ADDENDUM NO. 01

Project: **2024 Jersey Village High School Renovation**
Cypress-Fairbanks Independent School District

Issued by: Texas Arcadis Inc.
P.O. Box 891209
Houston, Texas 77289
281-286-6605

Texas Arcadis Inc.
Project No.: 202319

A0.16
 AREA 'R1' 1ST FLOOR DEMO PLAN

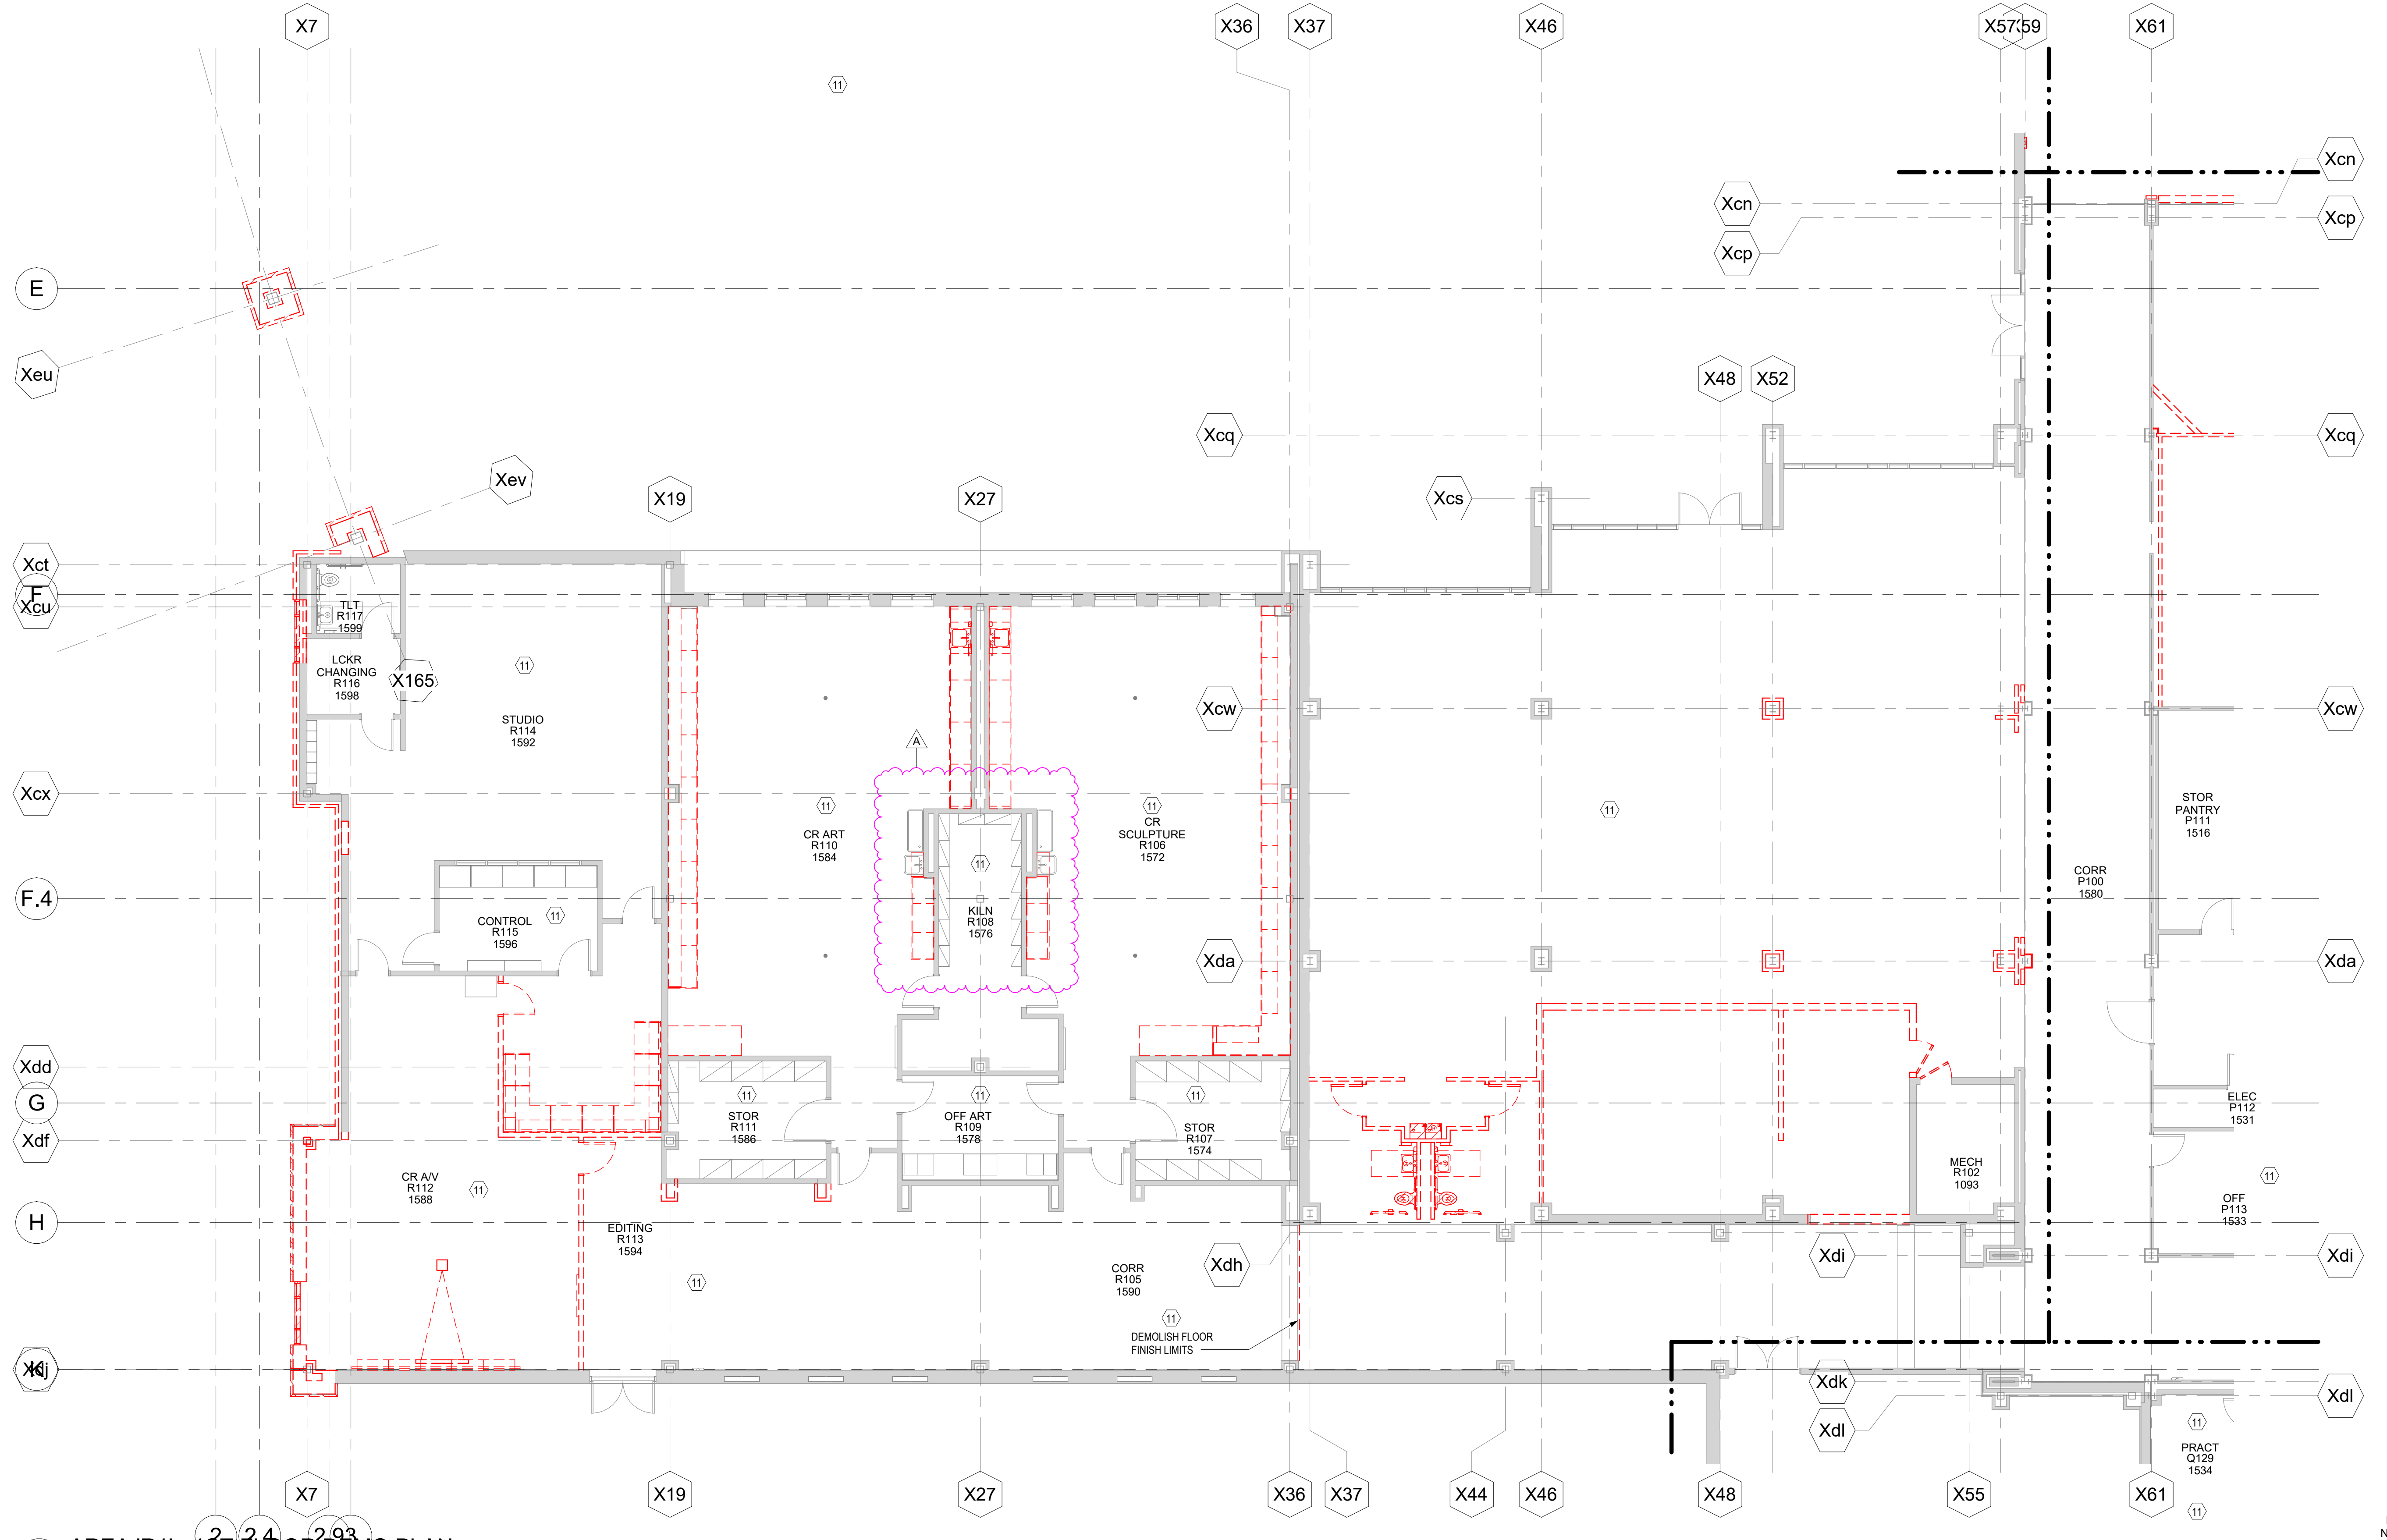
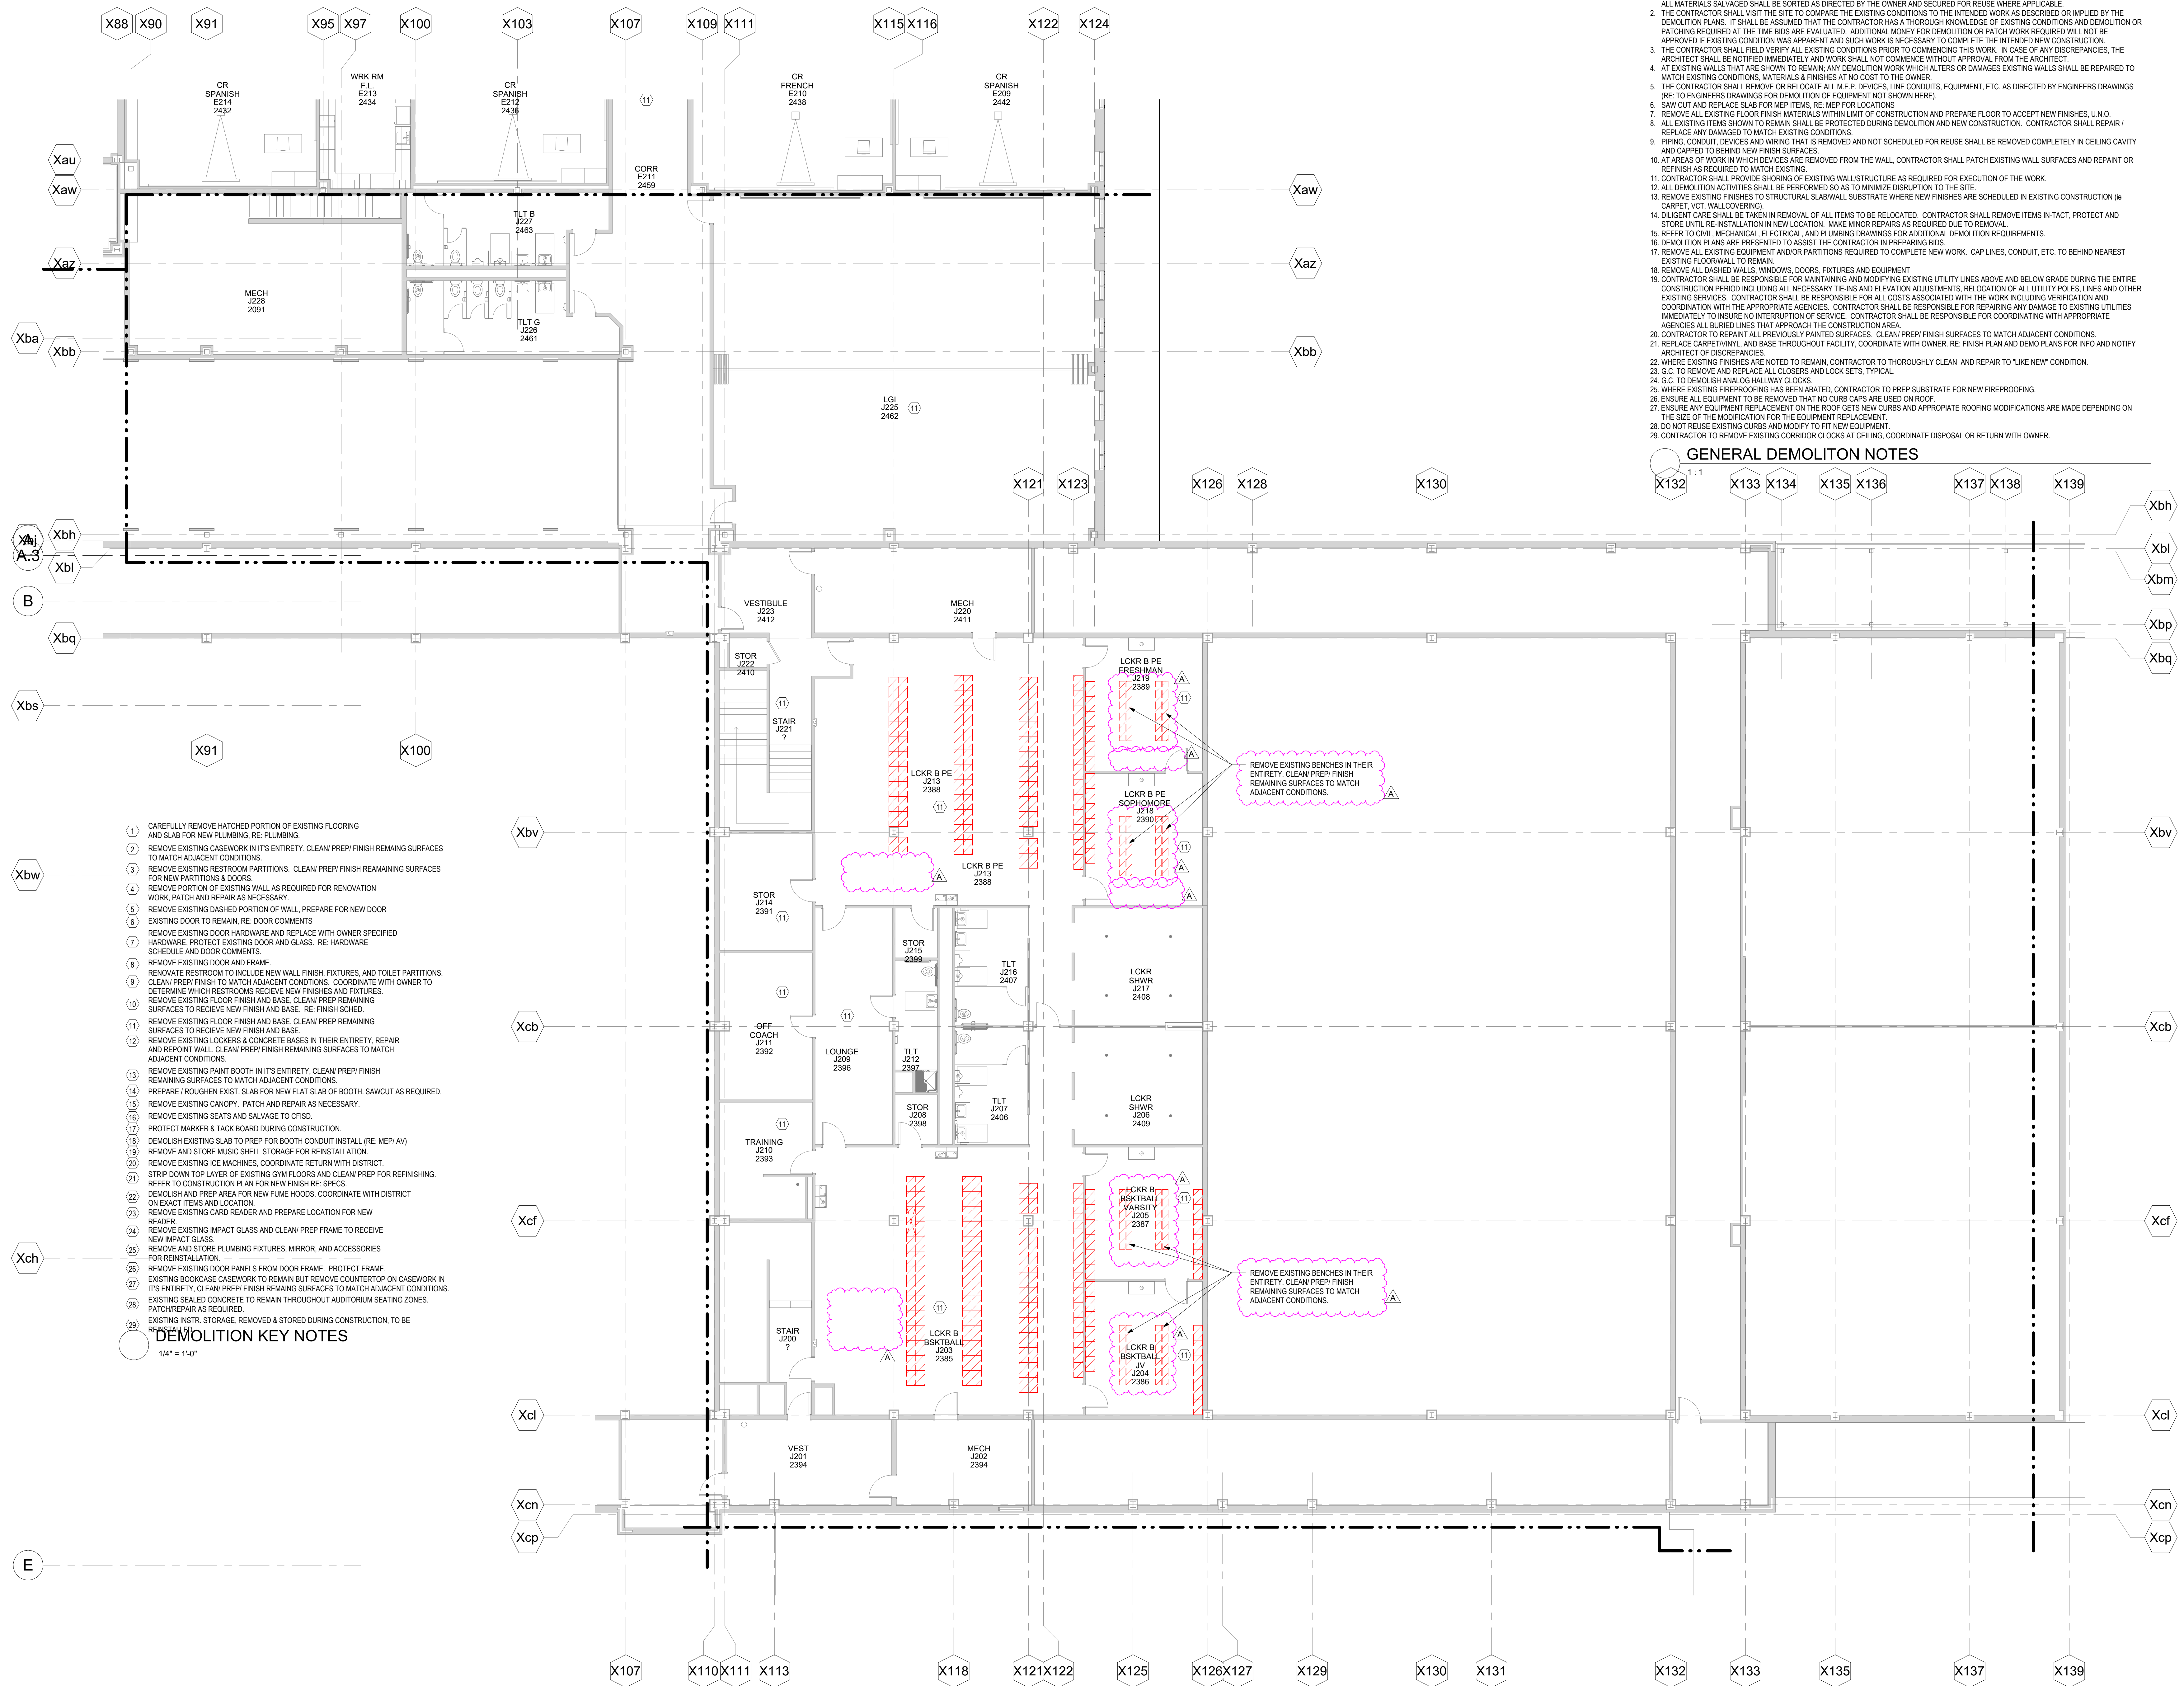
58. Sheet A0.16 - Area “R1” 1st Floor Demo Plan
 - a. Revise CR ART R110, CR SCULPTURE R106 demolished casework
59. Sheet A0.24 - Area “J2” 2nd Floor Plan
